Coastal Works Review

Garvin Park – Repair and Extension of Existing Dock and Replacement of Existing Boat Ramp Block: 9A Parcel: 127 (See addendum and appendix 2 for modification- excavation of dock area)

PREPARED FOR: MINISTRY OF HEALTH, ENVIRONMENT, CULTURE AND HOUSING

March 15, 2021

Figure 2: Plan extracts showing the proposed docks and boat slips (Reed Consulting Engineers 2019)

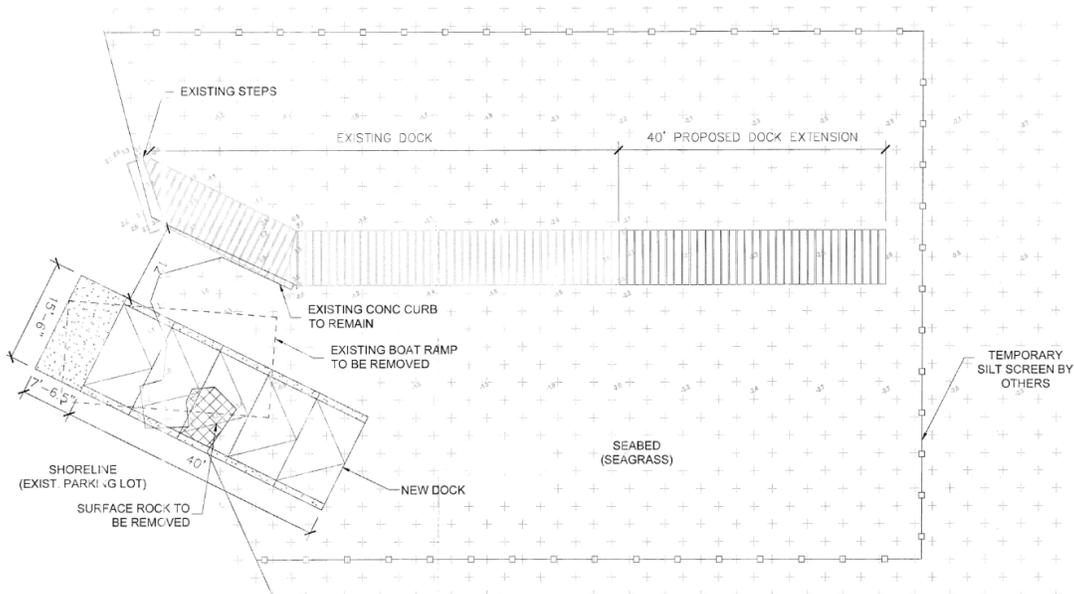
The existing shore perpendicular dock shall be repaired by replacing deteriorated wood framing members and adding deck joists to support the existing TREX deck boards. The proposed dock extension shall measure 40ft long by 8ft 1in wide as shown on stamped approved plans and Figure 2. It will be supported by 8in diameter concrete reinforced PVC pilings auger drilled into the seabed and, as with existing dock section, have TREX decking with a minimum of 1/2in spacing between decking boards. The pilings will be embedded by auger drilling the seabed using machinery mounted on a floating platform.

The boat ramp shall consist of a shore perpendicular reinforced concrete slab measuring 47ft long, 15ft 6in wide and 1ft thick (15 cubic yards of concrete) with 1ft 3in thick concrete curbs along the outer side edges (10 cubic yards of concrete) as shown on stamped approved plans and Figure 2. The area of the existing ramp and the proposed ramp,

including a 2ft wide area around the sides and end of the ramp, shall be excavated from the existing grade to a maximum depth of 4ft to embed the end ramp to 3ft below mean sea level. The seaward footing of the ramp shall be excavated to 5ft below mean sea level. This will result in the excavation of a total volume of 46.2 cubic yards of material. The boat ramp area shall be excavated by shore based excavator. A silt screen will be used to contain the entire area of the works whilst they are being carried out. As a part of the works the application also proposes a geotechnical survey to establish the substrate of the seabed to the pile embedment depth of 3ft below seabed level. It is proposed that at 3 locations along the length of the proposed dock, a steel rod shall be hammered into the seabed using a hydraulic hammer. No silt screens are proposed to be used at this stage as there should be very little disturbance.

In the cover letter submitted with the application it is mentioned that the ‘intention is to dredge an appropriate channel at a later date’ in order to allow 3ft of draft in order for larger boats to access the ramp and dock. The DOE would not recommend approval of such a proposal due to the lack of a need for access by larger boats and the significant environmental impacts that such works would likely have on the area. Any area of dredging would result in total seagrass loss in that area and would expose the coastline to greater wave action due to the deeper area of water closer to shore, likely leading to greater coastal erosion, which is already an issue for this area.
